PLAT COMMITTEE

September 11, 2024

Case Number:	2024-PLT-057
Property Address:	9401, 9415 East Southport Road, 9404 & 9510 East McGregor Road, 7420 and 7240 Hickory Road (approximate addresses)
Location:	Franklin Township, Council District #25
Petitioner:	Brookfield Joint Venture, by Taylor Navarre
Zoning:	D-4 (FF)
Request:	Approval of a Subdivision Plat, to be known as Crescent Ridge, dividing 112.45 acre into 180 lots, with one cul-de-sac at a length of 980 feet, with a waiver of maximum 500-foot length of the cul-de-sac requirement, per Chapter 741, Article III, Section 3.D of the Consolidated Zoning and Subdivision Ordinance.
Current Land Use:	Undeveloped
Staff Reviewer:	Michael Weigel, Senior Planner

2024-PLT-057 ; Primary Plat (Detail)

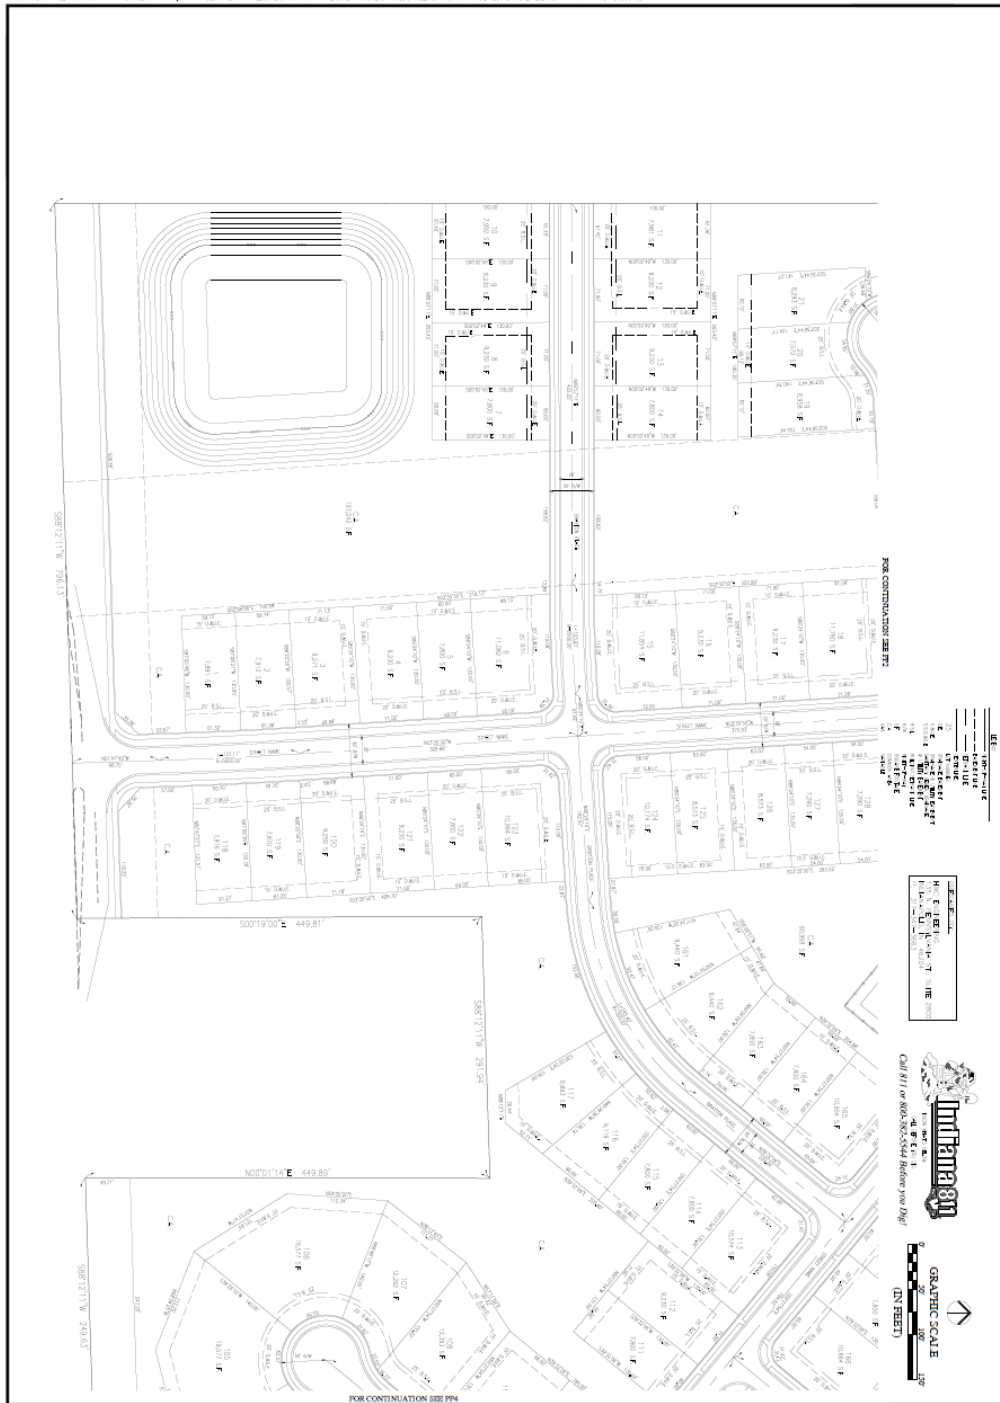
12. That the requested waiver of maximum 500-foot length of the cul-de-sac requirement, per Chapter 741, Article III, Section 3.D of the Consolidated Zoning and Subdivision Ordinance, be approved on the condition that the 15-foot-wide pedestrian access/public utility easement required by 741-303 be affixed to the final plat prior to recording.

13. That required sidewalks along Hickory Road and the portions of the plat with frontage along McGregor Road be affixed to the final plat prior to recording.

Sidewalks are required along Southport Road, McGregor Road, Hickory Road, and all proposed interior streets. A condition has been added to ensure that required sidewalk would be shown on the plat along the southeastern portion fronting on McGregor and along Hickory prior to final recording.
